**MINERALS PROGRAM INSPECTION REPORT**  
**PHONE: (303) 866-3567**

<b>MINE NAME:</b> Rocky Ford East Pit	<b>MINE/PROSPECTING ID#:</b> M-1977-560	<b>MINERAL:</b> Sand and gravel	<b>COUNTY:</b> Otero
<b>INSPECTION TYPE:</b> Surety Release Inspection	<b>INSPECTOR(S):</b> Amy Eschberger	<b>INSP. DATE:</b> April 25, 2019	<b>INSP. TIME:</b> 11:00
<b>OPERATOR:</b> VALCO, Inc.	<b>OPERATOR REPRESENTATIVE:</b> Tom Brubaker	<b>TYPE OF OPERATION:</b> 112c - Construction Regular Operation

## Response to Reclamation Permit Partial Acreage Release Request Consideration

DATE: April 16, 2019  
TO: Amy Eschberger, Environmental Protection Specialist  
CC: Division 2 Office; District 17 Water Commissioner  
FROM: Ivan Franco, P.E. *HIF*  
RE: Rocky Ford East Pit, File No. M-1977-560 and M-2017-032  
Operator: Valco, Inc.  
Contact: Tom Brubaker  
Sec. 21, Twp. 23S, Rng. 56W, 6<sup>th</sup> P.M., Otero County

# ROCKY FORD, CRYSTAL PIT

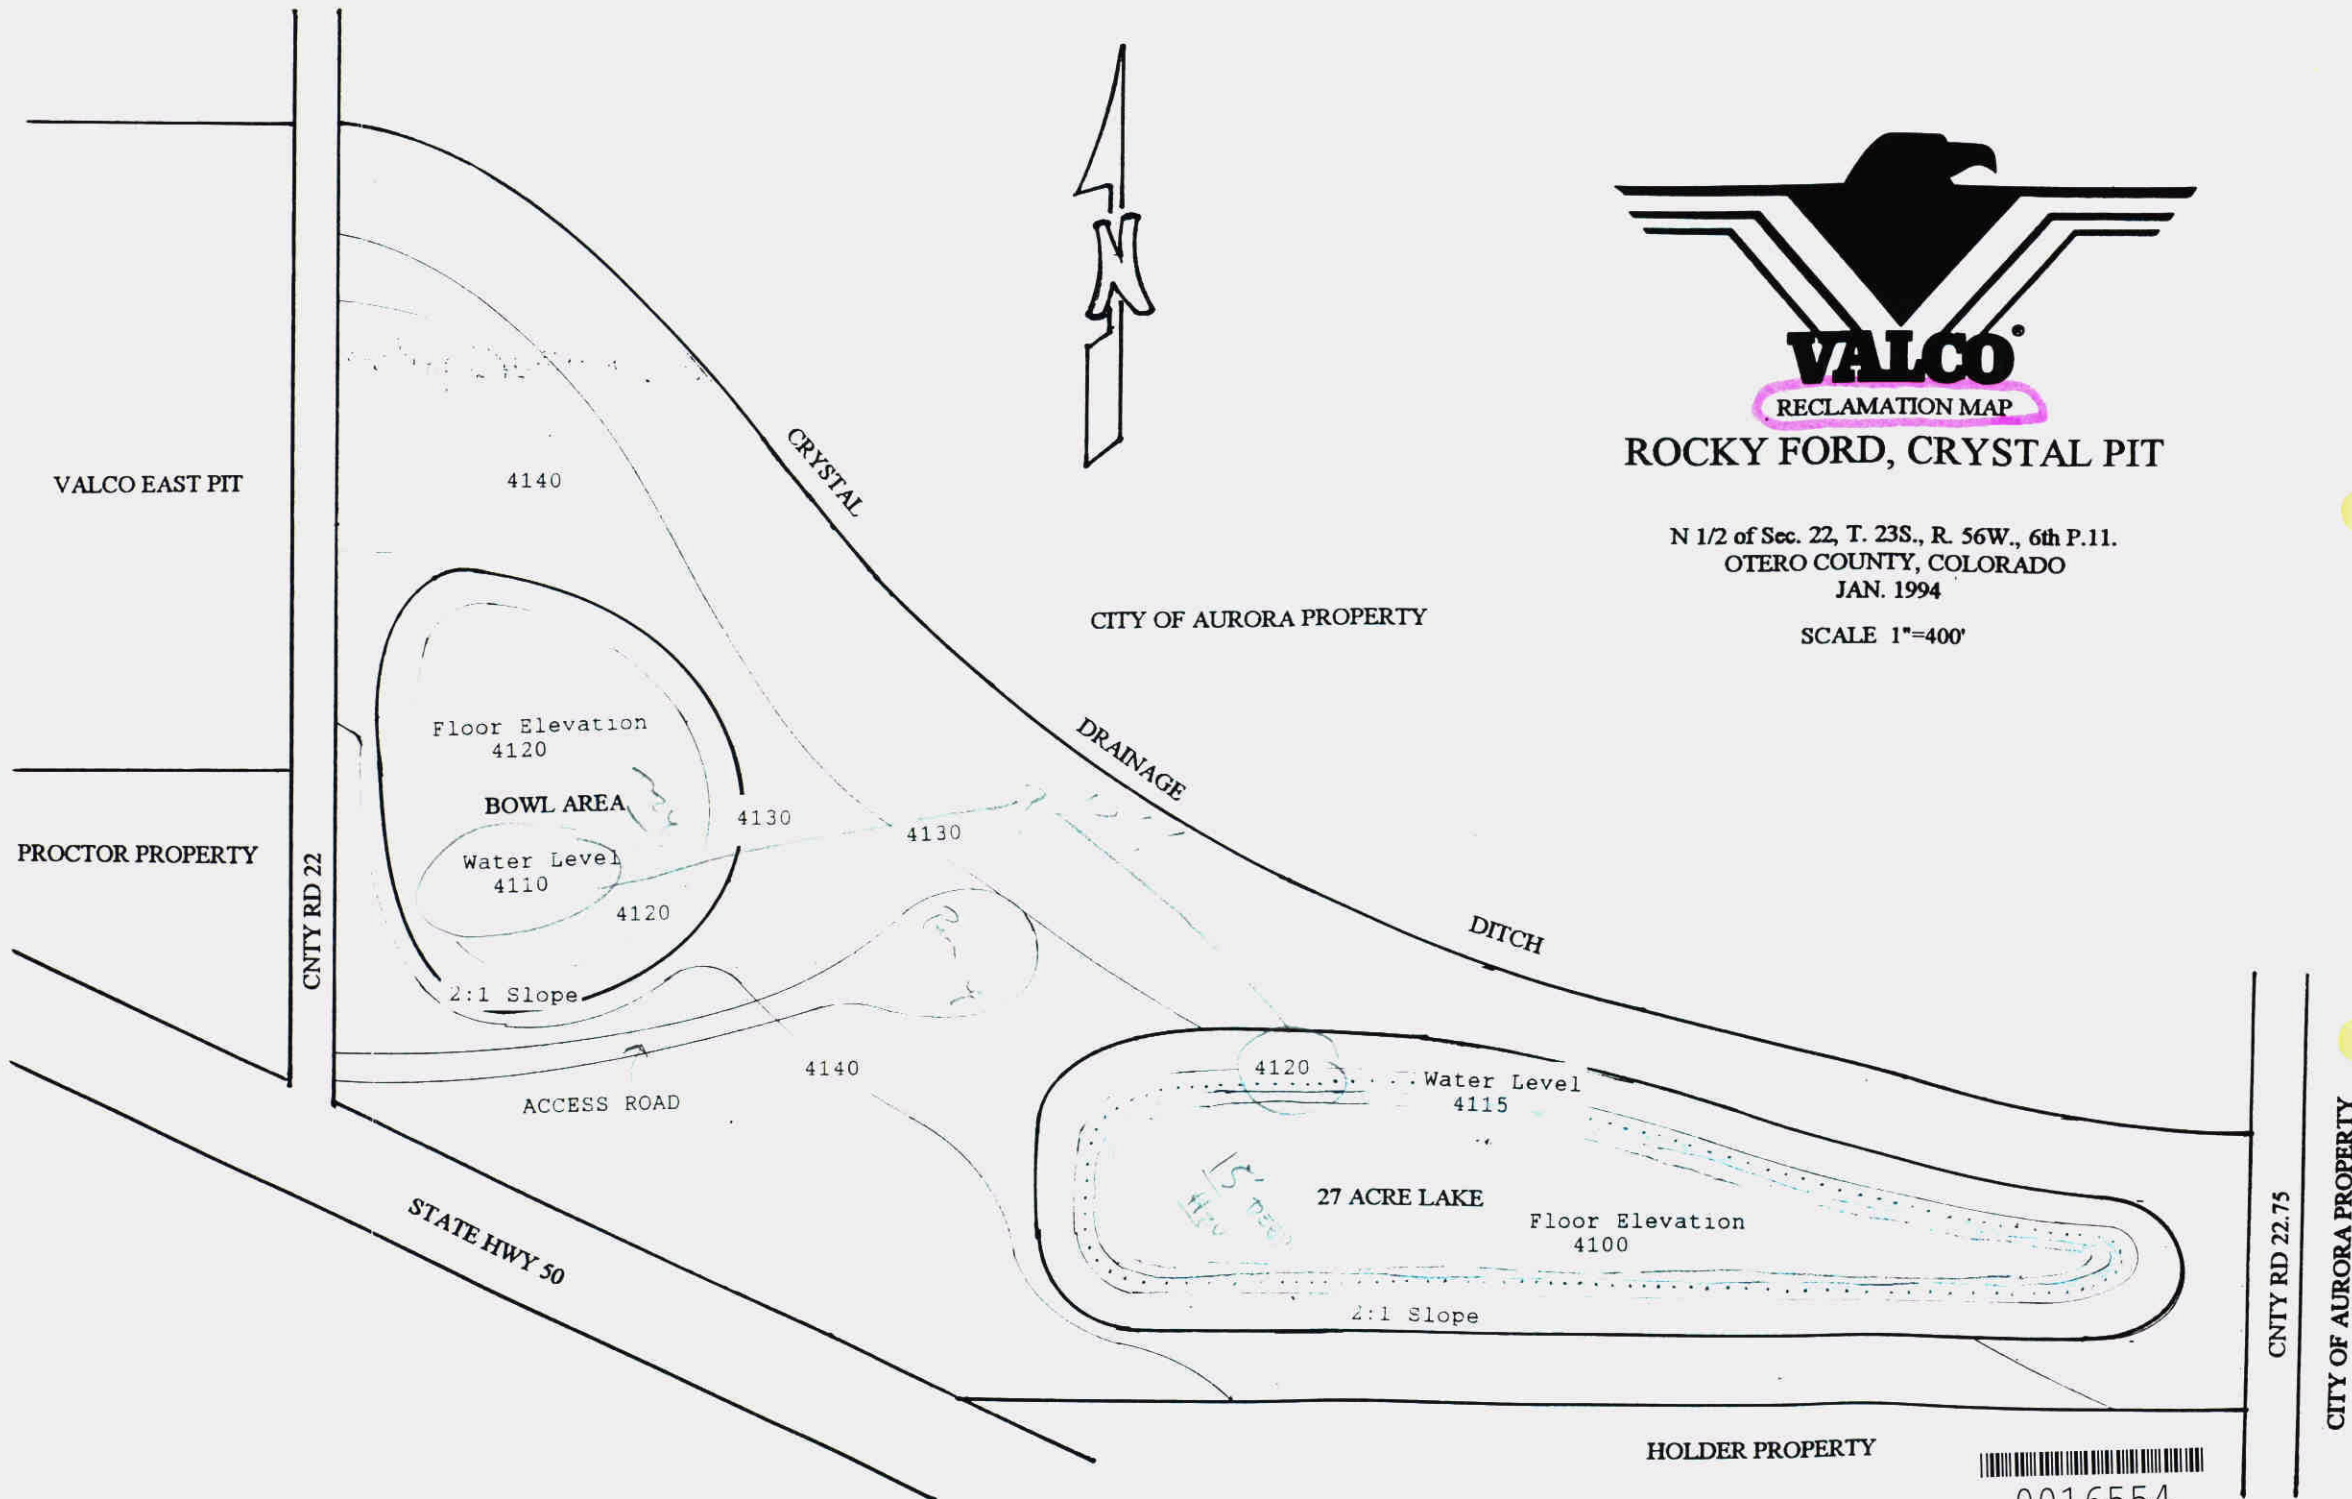
At this time, the operator has not implemented one of the approaches identified by the Division in its April 30, 2010 letter. While the operator has indicated plans to backfill the ponds, this has not yet been completed at the site. Additionally, the approved reclamation plan (see enclosed reclamation plan map) does not include backfilling the ponds. Therefore, the Division is citing a problem in this report for the exposed groundwater (see page 1), requiring the operator to either provide evidence that a permanent augmentation plan has been obtained to cover the exposed groundwater, or submit a Technical Revision to update the reclamation plan and map to reflect existing and proposed activities, particularly backfilling the exposed groundwater. The revision will also need to include a detailed timeline for completion and a revised bond estimate. As mentioned above, the operator should aim to complete reclamation of the eastern parcel by early 2021 to maintain compliance with Rule 3.1.3.

**CORRECTIVE ACTIONS:** By the corrective action due date, the operator shall submit a Technical Revision, with the required \$216 revision fee, to update the reclamation plan and reclamation plan map to reflect existing and proposed activities, particularly backfilling the exposed groundwater. This revision shall also include a detailed timeline for completion and a revised bond estimate. Alternatively, the operator may provide evidence that a permanent augmentation plan has been obtained to cover all existing groundwater exposure at the site.
